Case File / Name: ASR-0052-2022 DSLC - 2251 Charles Drive Multi-Family, Mixed-Use Apts

LOCATION:This site is located on the north side of Glenwood Avenue, west of Lead Mine
Road, at 2251 Charles Drive.REQUEST:This is an AA revision update to the previously signed Administrative Action (AA)
Document for ASR-0052-2022 "2251 Charles Drive Multi-Unit Apartment,"
correcting the proposed building gross area for the proposed multi-module building
types only.

FINDINGS: City Administration finds that this request, with the below conditions of approval being met, conforms to the Unified Development Ordinance. This approval is based on a preliminary plan dated April 14, 2023 by J DAVIS ARCHITECTS.

L0.1

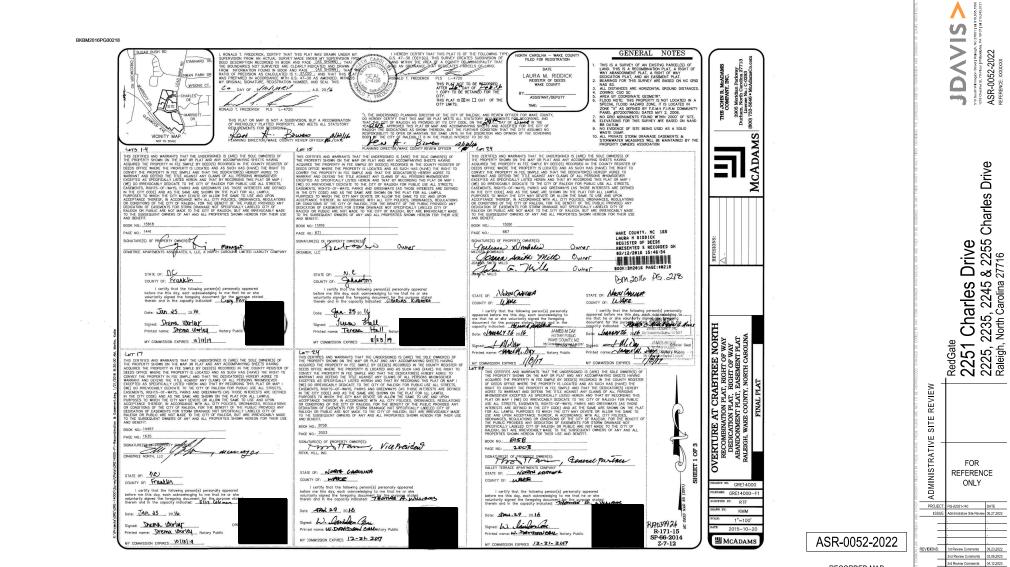
1. THE FOLLOWING USES SHALL BE PROHIBITED ON THE PROPERTY:

2. PRIOR TO THE ISSUANCE OF ANY BUILDING PERM T FOR THE PROPERTY OR A SUBDIVISION OF THE PROPERTY, WHICHEVER SHALL OCCUR FIRST, THE OWNER OF THE PROPERTY SHALL CONVEY TO THE CITY OF RALEIGH A TRANSIT EASEMENT MEASURING TWENTY (20) FEET BY FIFTEEN (15) FEET WITH A CONCRETE PID AND TRANST SELTER. THE LOCATINO OF THE EASEMINT SHALL BE PROVIDED BY THE PIBLIC WORKS DEPARTMENT, TRANST DIVISION OF THE CT AND THE CIT AT TORMEY SHALL APPROVE THE TRANST EASEMINT DEED PIBLIC TO RECORDATION, PIBLIC TO STIANING A CERTIFICATE OF OCUMARY CT OR AN THE WILLINGS OF THE PROPERTY, THE WORKS VILL CONSTRUCT THE CONCRETE PID AND SHETTER REFERENCED IN THIS CONDITION WITHIN SUCH TRANST EASEMENT, UILES THIS REQUERTING TO SWATE DIVISION THE CIT OF ANISTE

3. LYCPN REDVELOPMENT, THERE WILL BE A MINIMUM OF 2505 SQLUBRE FEET OF "BETAIN" DEVELOPMENT AS DERINGIN OCO SECTION DISADZO ON THE PORTERY HOWLVER. TOTA BETAIL DEVELOPMENT AS DEFINED IN COD SECTION DISADZO ON THE OPERTY HOWLL NOT DECEDA DITALO OF 2500 GUARTINE HET. THE TOTA RESIDENTIA ZO RESTOR TO THE ROPERTY SHALL NOT DECEDA 533 UNITS, OFFICE USS AS DEFINED IN CODE SECTION 10-8020 WILL NOT BE ALLOWED, EXCEPT AS INCODITAL AND ACCISSOR TO RESIDENTIA LISSS.

6. EXTEROR RULDING SUBFACTS FRONTING ON, ALEXCENT TO AND VISIEL FROM FUBLIC RIGHT OF WAY SHALL CONSIST OF ALL SATE RISK REALS, STORIE OF ANGONY WINERE, RICLUSUP OF ROOS, WINDOWS, STOREFRONTS IS AD FERIND BLOW), DOOR CORNECTS AND TRIN, OTHER EXTERIOR DUINOS SUBFACES SULL CONSIGT OF ALL LEAST SYS BRICS, TORIE OR MAXIONEY OF WERE REXLULVES OF ROODS, WINDOWS, STOREFRONTS IS DEFINED BLOW), DOORS, CORNICTS AND TRIM. NO PETERNAL BUILDING SUBFACES SULL CONSIGT OF ALL SATES SWITCH ON RULDING SUBFACE SOLL CONSIGT OF ALL SATES SWITCH ON RULDING SUBFACE SOLL CONSIGT OF ALL SATES SWITCH ON RULDING SUBFACE SOLL CONSIGT OF ALL SATES SWITCH ON RULDING SUBFACE SOLL CONSIGT OF ALL SATES SWITCH ON RULDING SUBFACE SALL CONSIGT OF ALL SATES SWITCH ON RULDING SUBFACE SALL CONSIGT OF ALL SATES SWITCH ON RULDING SUBFACE SALL CONSIGT OF ALL SATES SWITCH ON RULDING SUBFACE SALL CONSIGT OF ALL SATES SWITCH ON RULDING SUBFACE SALL CONSIGT OF ALL SATES SWITCH ON RULDING SUBFACE SALL CONSIGT OF ALL SATES SWITCH ON RULDING SUBFACE SALL CONSIGT OF ALL SATES SWITCH ON RULDING SUBFACE SALL CONSIGT OF ALL SATES SWITCH ON RULDING SUBFACE SALL CONSIGN OF ALL SATES SWITCH ON RULDING SUBFACE SALL CONSIGN OF ALL SATES SWITCH ON RULDING SUBFACE SALL CONSIGN OF ALL SATES SWITCH ON RULDING SUBFACE SALL CONSIGN OF ALL SATES SWITCH ON RULDING SUBFACE SALL CONSIGN OF ALL SATES SWITCH ON RULDING SUBFACE SALL CONSIGN OF ALL SATES SWITCH ON RULDING SUBFACE SALL CONSIGN OF ALL SATES SWITCH ON RULDING SUBFACE SALL CONSIGN OF ALL SATES SWITCH ON RULDING SUBFACE SALL CONSIGN OF ALL SATES SWITCH ON RULDING SUBFACE SALL CONSIGN OF ALL SATES SWITCH ON RULDING SUBFACE SALL CONSIGN OF ALL SATES SWITCH ALL SATES SWITCH AND RULDING SUBFACE SALL CONSIGN OF ALL SATES SWITCH ALL SATES CONSIGN OF ALL SATES SWITCH ALL SATES CONSIGN OF ALL SATES SWITCH ALL SATES SWITCH ALL SATES CONSIGN OF ALL SATES SWITCH ALL SATES SWITCH ALL SATES CONSIGN OF ALL SATES SWITCH ALL SATES SW

9. GABAGE DUMPSTES/COMPACTORS SHALL BE SKEENED FROM YEVE FROM JOINE AND ADJACENT PROPERTIES AND PUBLIC RIGHT-OF-WAY, PROVIDED, THAT ANY ENCLOSURES MAY HAVE GATED OPENINGS TO BE OPENED WHEN DUMPSTES/COMPACTORS ARE ENC EMPTY ADJACENT DUPENINGS TO BE CONSTRUCTO FROM THE SAME MATTERIALS AS THE PRINCIPAL BUILDINGS THEY SERVICE AND SHALL INCLUDE & WOOD THELS COVERING ALL LEAST SKYO FTH EACLOSURES.

12. AT LEAST 30 VEHICULAR PARKING SPACES WITH ELECTRIC CHARGING FACILITIES SHALL BE PROVIDED ON SITE

RESPONSE: THE PROPOSED DEVELOPMENT IS MULTI-UNIT LIVING AND RETAIL. A PARKING STRUCTURE AS NOTED ON THE SITE PLAN. NONE OF THE ABOVE USES ARE PROPOSED WITHIN THIS PROJECT.

RESPONSE: THE TRANSIT EASEMENT WAS PROVIDED WITH OVERTURE AT CRABTREE NORTH PROJECT, CITY OF RALEIGH CASE NUMBER SP-66-14 AND IS LOCATED ADJACENT TO LEAD MINEROAD. THE EASEMENT IS RECORDED IN BM 2016, PAGE 218.

RESPONSE: OVERTURE CONTAINS 203 UNITS, THIS PROJECT PROPOSES 330 UNITS FOR A TOTAL OF 533, THE MAXIMUM ALLOWED. OVERTURE CONTAINS 2500 SF OF RETAIL; THIS PROJECT PROPOSES 2500 SF OF RETAIL FOR A TOTAL OF 5,000 SF WHICH IS BELOW THE 7,500 SF MAXIMUM

RESPONSE: THE MARRIOTT DRIVE AND CHARLES DRIVE ELEVATIONS FRONT PUBLIC STREETS AND MEET OR EXCEED THE MATERIAL PERCENTAGES REQUIRED BY THE ZONING CONDITIONS. ALL OTHER ELEVATIONS THAT ARE ADJACENT TO A REAR INTERIOR DRIVE, NOT A PUBLIC STREET, HAVE MASONRY COVERAGE MEETING OR EXCEEDING ZONING COND TION REQUIREMENTS.

RESPONSE: THE SOLID WASTE ROOM IS WITHIN THE BUILDING LOCATED ON THEWEST SIDE AND IS ACCESSIBLE FROM THE PROPOSED INTERNAL PRIVATE DRIVE: SEE BUILDING ELEVATIONS FOR CREENING MATERIALS

BESPONSE: THIS PROJECT PROPOSES 23 PARKING SPACES WITH ELECTRICAL CHARGING STATIONS. THE OVERTURE AT CRABTREE NORTH PROVIDED & SPACES. THE TOTAL 30 PARKING SPACESWITH ELECTRICAL CHARGING STATIONS WILL BE MET FOR THE ENTIRE PROPERTY.
